CPUC Docket: A.22-08-003
Witness: Jalal Awan
Exhibit: TURN-03

PREPARED SUPPLEMENTAL TESTIMONY OF
JALAL AWAN

SUPPLEMENTAL TESTIMONY CONCERNING PG&E'S REVISED ZONAL
ELECTRIFICATION PILOT PROJECT (DATED JUNE 27, 2024)

5
 6 **Figure 1 HPHW Costs in Single-Family Homes California (2022-2024)**

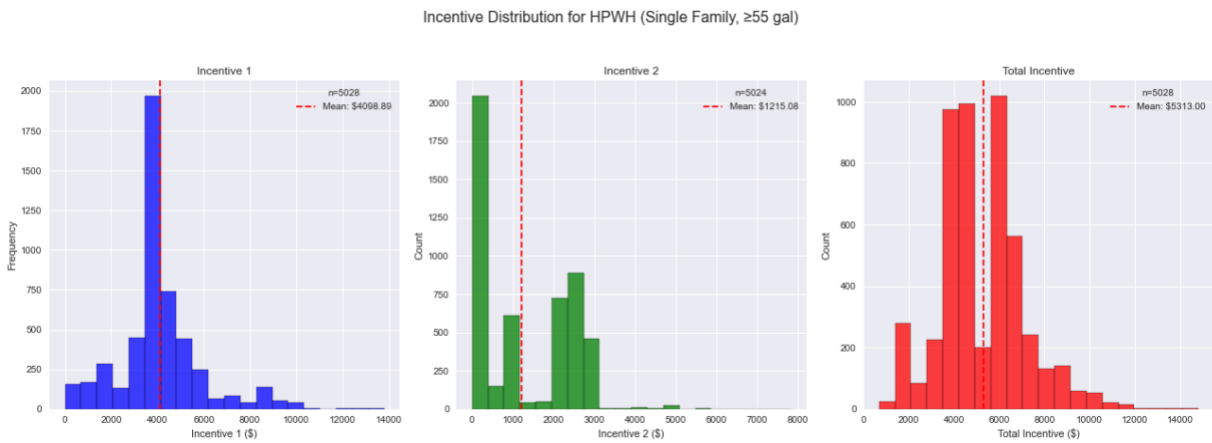
18 PG&E includes \$5,500 as the estimated cost per unit for heat pump water heater (HPHW)
19 installation. TURN’s analysis based on the TECH working dataset of approximately 8,000
20 single-family HPWH projects in California suggests a more realistic cost of \$7,602 for HPHW

1 costs.²⁰ Figure 1 shows the distribution of average Total Project Costs for ≥ 55 -gallon HPWH
 2 from 2022-2024 in California. As these graphs show, the average cost was \$7,584 in 2022,
 3 \$7,520 in 2023, and \$7,701 in 2024. TURN recommends using the average of 2022-2024 costs
 4 (i.e. \$7,602) as a reasonable estimate for HPWH cost.
